RESOLUTION SETTING HEARING ON REQUEST FROM EASTGATE PLAZA, LLC FOR APPROVAL OF A PROPOSED 7TH AMENDMENT TO THE EASTGATE PLAZA PUD CONCEPTUAL PLAN ON PROPERTY LOCATED IN THE VICINITY OF 1534 EAST EUCLID AVENUE

Communication from the City Plan and Zoning Commission advising that at their February 3, 2022 meeting, the following action was taken regarding a request from Eastgate Plaza, LLC (owner), represented by Norman S. Weinstein (officer), for review and approval of a 7th amendment to the Eastgate Plaza PUD Conceptual Plan on the property located in the vicinity of 1534 East Euclid Avenue, to allow development of a 7,500-square-foot medical office building.

DAVITA EAST DES MOINES DIALYSIS

AN AMENDMENT TO THE EASTGATE PLAZA P.U.D. (PLANNED UNIT DEVELOPMENT)

EXTERIOR ELEVATIONS

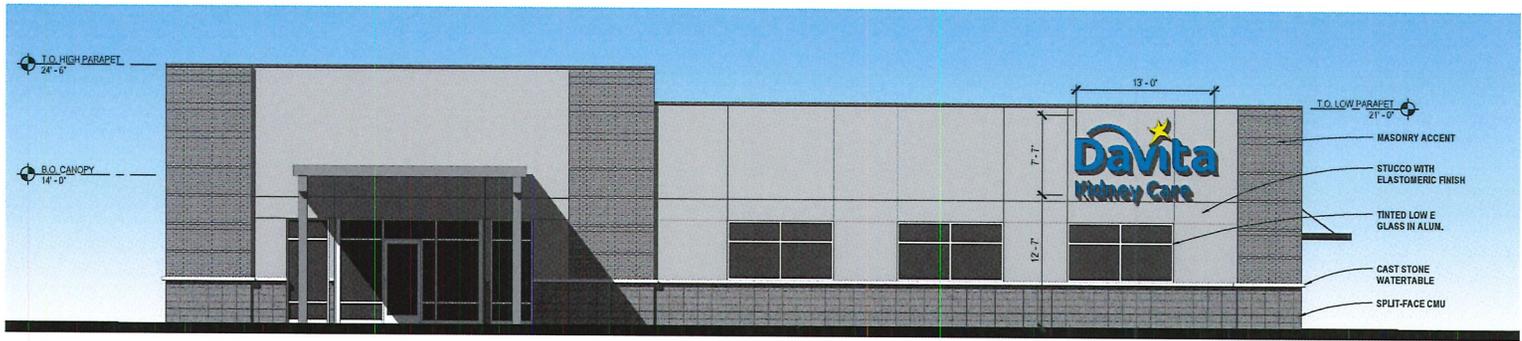
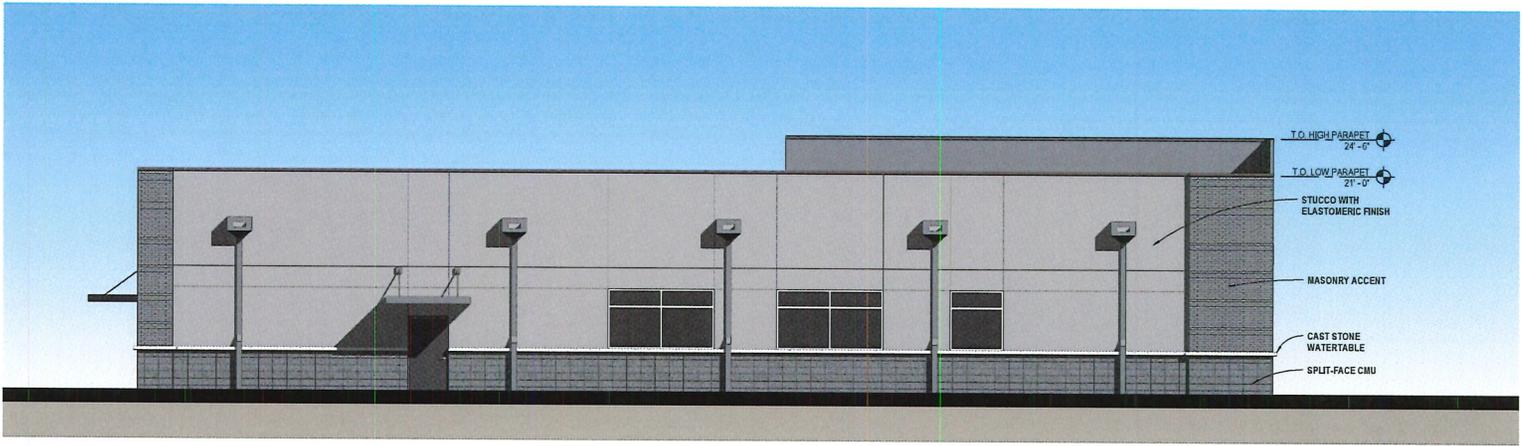
6. **Urban Design:** The proposed building would be sided with a mix of stucco with elastomeric finish (EIFS) and split-face concrete masonry units (CMU). Brick would be used as an accent material. EIFS is typically limited to the third floor or higher in commercial buildings (Section 135-4). Staff believes that the building should primarily be sided with materials that are classified as "Major Façade Materials" by Chapter 135 of the Municipal Code. In addition, the amount of transparency (windows) and the transmittance factor of the windows should be comparable to what is required by Chapter 135. To allow flexibility for the applicant and staff to work on design solutions during the development of the PUD Development Plan, staff recommends a general condition that points back to the standards found in Chapter 135.

- 4) Provision of a note that states landscaping shall be provided in accordance with Chapter 135: Planning and Design Ordinance.
- 5) Provision of a note that states the building shall be sided with materials that comply with Chapter 135: Planning and Design Ordinance to the satisfaction of the City's Planning and Urban Design Administrator.

- 6) Provision of a note that states windows and doors shall be provided that comply with the relevant transparency, transmittance and reflectance factors found Chapter 135: Planning and Design Ordinance to the satisfaction of the City's Planning and Urban Design Administrator.
